S.B. Knitting Ltd.

Baipal Notunpara, New DEPZ, Savar, Dhaka
(23.94544, 90.27674)
15th April 2014

Undocumented Vertical Extension

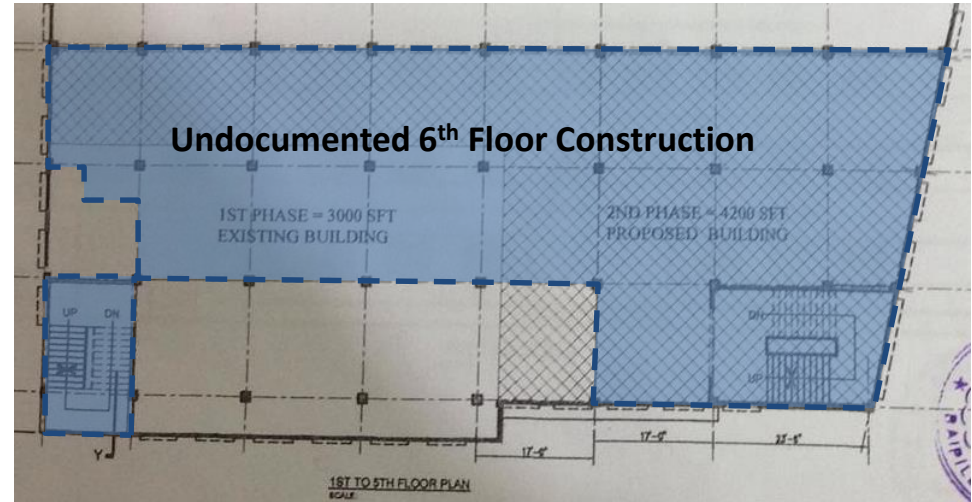
Vertical extension on roof comprising lightweight steel trussed roof on concrete columns with brick masonry infill. Typical Slab used to transfer masonry perimeter wall loads to columns. No structural or design documentation provided for extension.

Lateral Stability system for 6th floor structure not clear.

Tie-downs for wind uplift on roof not detailed or apparent during inspection.

Item No.3	Observation	Recommended Action Plan	Recommended Timeline
1	Undocumented vertical extension	Building engineer to verify structural design of additional structures, with particular attention to structural stability and roof tie-down	6-weeks
2	Undocumented vertical extension	The building engineer should check the level 6 structural arrangement and confirm that the main building structure is capable of safely supporting the additional structures.	6-weeks
3	Undocumented vertical extension	Implement any actions arising from the Engineering assessments of the additional construction and supporting slab structure.	6-months
4	Non-Engineered adjoining shed structures	Building engineer to review the structures and structural design of the adjoining sheds in detail, with particular attention to the larger shed used for production operations. Structural stability, vertical load paths, steelwork connection details, to be specifically addressed	6-weeks

Non-Engineered Adjoining Shed Structures

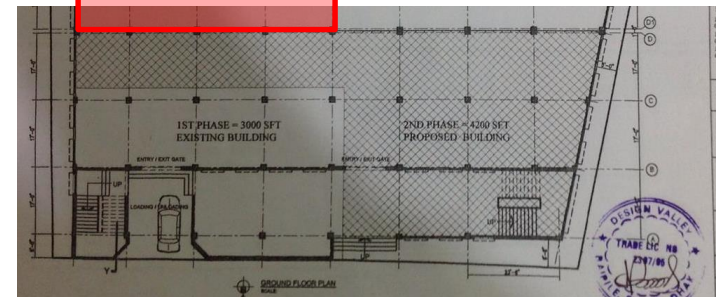
**Non Engineered shed,
connected to main
building façade.**

**Damage and distress to
reinforced concrete and
masonry cantilevered
walls**

**Threading Area
& toilet in Non
Engineered
Shed**

5	Non-Engineered adjoining shed structures	Carry out all recommendations from building engineer's assessment	6-months
6	Non-Engineered adjoining shed structures	Prepare appropriate structural as built drawings incorporating the completed structural frame once strengthening works are incorporated.	6-months

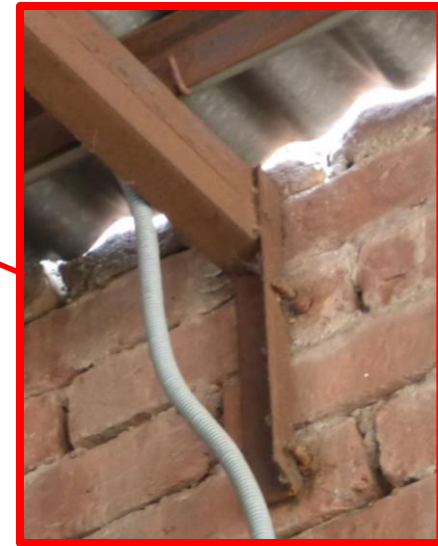
**Non Engineered trusses and internal posts.
No roof bracing system evident.
Distress and distortion of structural steelwork
evident
Purlins appear to be undersized for cantilever spans.**

Non Engineered shed,
connected to main
building façade.

Localised Areas of High Loading

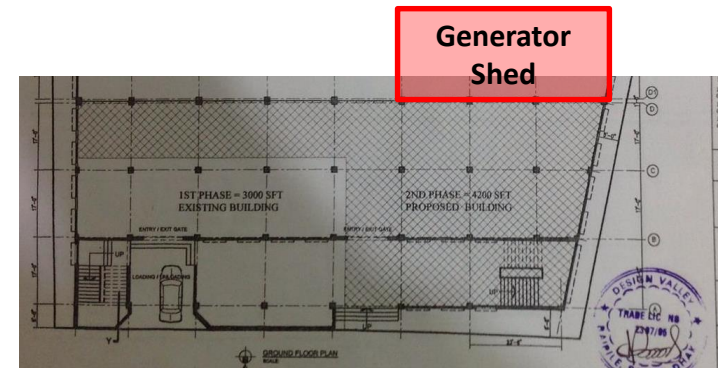
Building Generator
located in shed.

**Areas of localised high loading on suspended structure observed throughout building.
No load management procedure evident.**

Item No.	Observation	Recommended Action Plan	Recommended Timeline
7	Localised areas of high loading	Maintain current use of the floors and do not change use or increase occupation or loading prior to completion of safe loading plans by the building engineer	Immediate - Now
8	Localised areas of high loading	Building Engineer to create controlled loading plans for all floors, which account for existing solid partition loads, extra finishes, heavy fixed items etc. and are based on the structural capacity of supporting slabs, beams and columns in the as built arrangement	6-weeks
9	Localised areas of high loading	Factory management to display plans and educate all relevant factory management on implementation	6-weeks
10	Localised areas of high loading	Continue to implement load plan	6-months
11	Undocumented horizontal extension	Building engineer to verify structural design of additional cantilever and façade load position	6-weeks

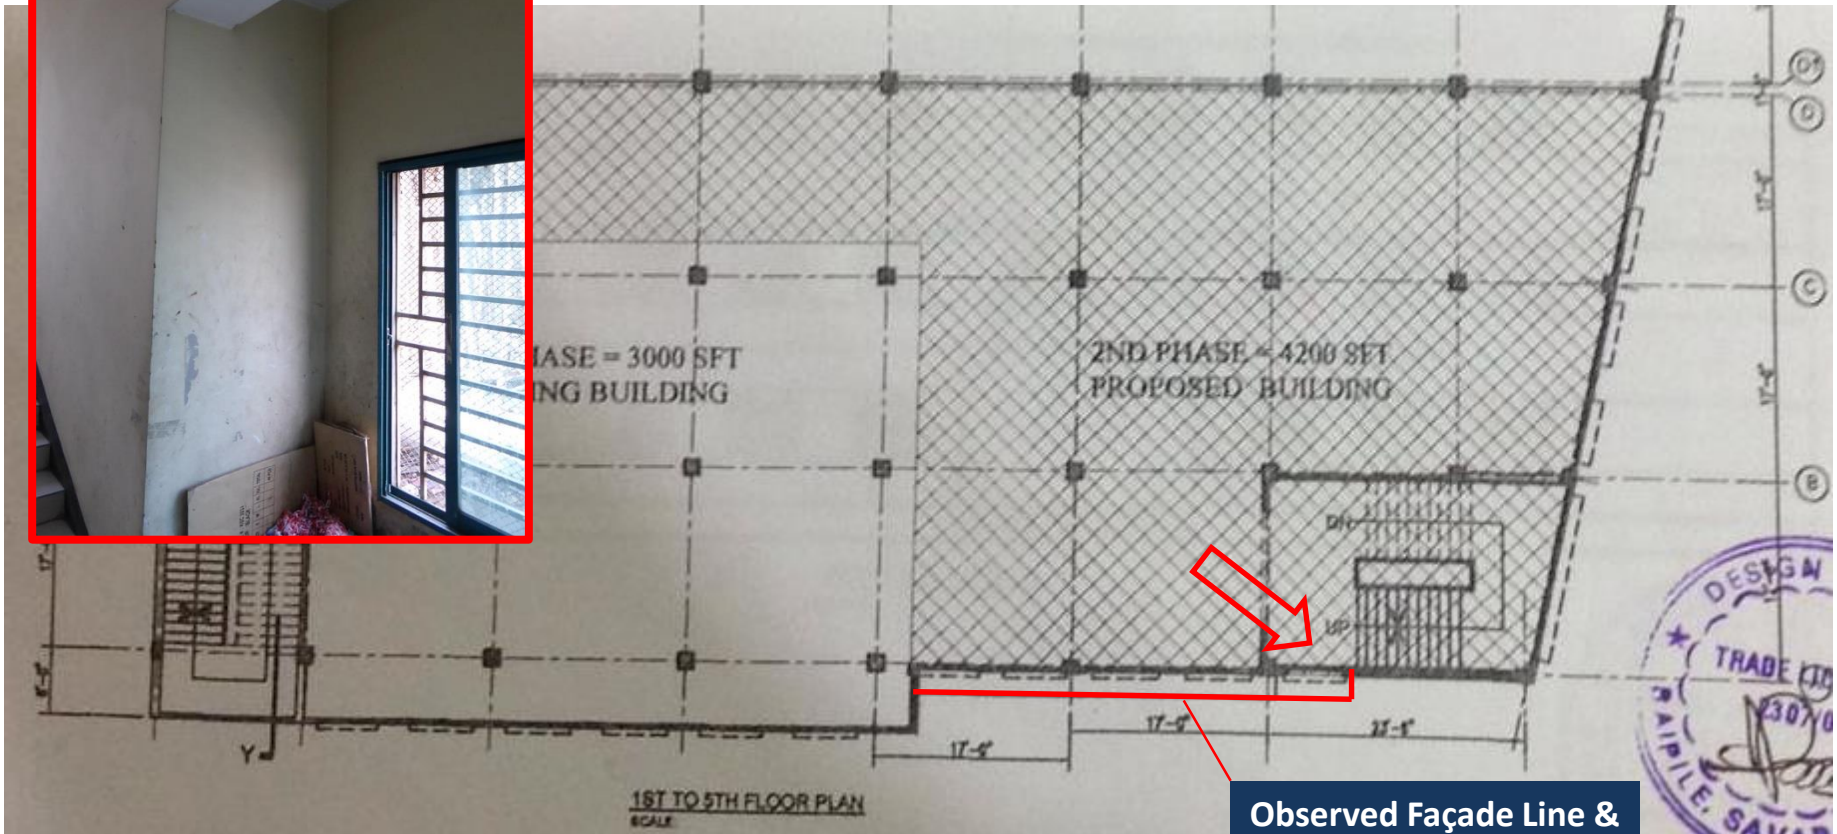
Numerous areas where load is stored on landings and half landings in both staircores.

Issue is raised insofar as it relates to loading. Building manager to review with their fire safety engineer soonest in relation to fire safety issues.

Toilet drainage infrastructure contained above structural slab level using multiple solid buildups. Additional loading from solid buildups (210mm on 255mm screed recorded) and solid partition walls recorded on bay containing toilet block.

Evidence of Distress in Façades and Solid Internal Partitions

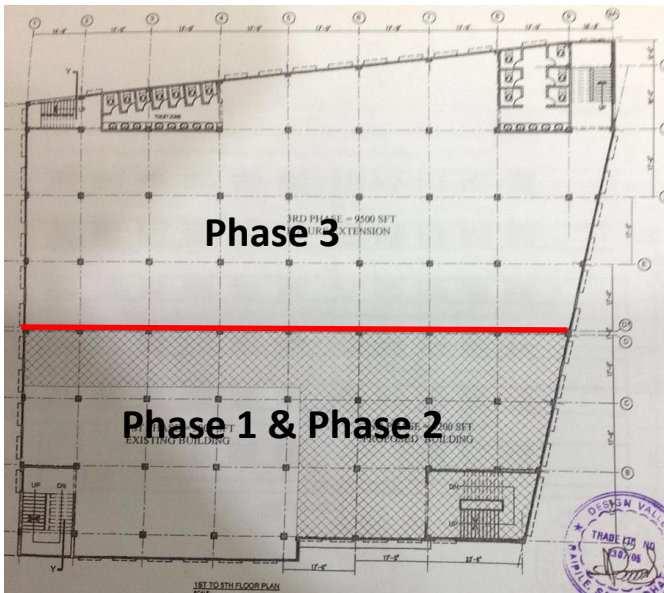
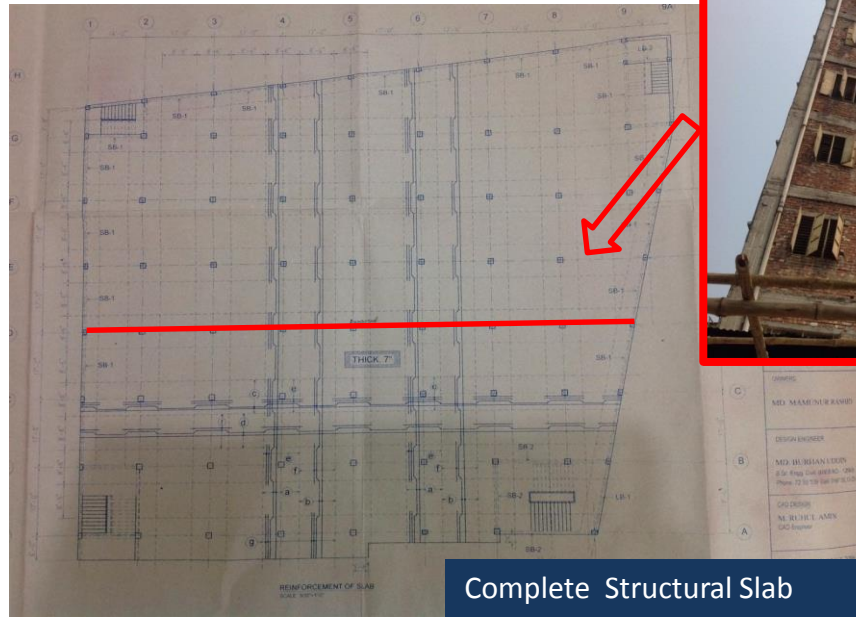
Evidence of distress on the rendered masonry façade where it is supported on both perimeter beams and flat slab cantilevers.

Cracking likely related to deflection of façade support structural elements, lateral load capacity of façade panel and differential thermal movement of façade and structure.

Evidence of significant prior distress and repair to internal partitions constructed without deflection heads to structural slabs.

Item No.	Observation	Recommended Action Plan	Recommended Timeline
14	Non-engineered external storage sheds	Building engineer to review all temporary structures on site and certify that building are fit for purpose and safe for occasional staff access	6-weeks
15	Non-engineered external storage sheds	Carry out strengthening or demolitions as advised by the building engineer	6-weeks
16	Non-engineered external storage sheds	Implement building manager's plans for appropriate permanent structures required to meet factory storage requirements	6-months
17	Evidence of distress in Facades and solid internal partitions	Building engineer to review façade panel design and ensure adequate capacity for applied lateral loads	6-weeks
18	Evidence of distress in Facades and solid internal partitions	Building management to continually monitor condition of façade and advise building engineer should any significant of cracking facades or solid partitions take place	6-months
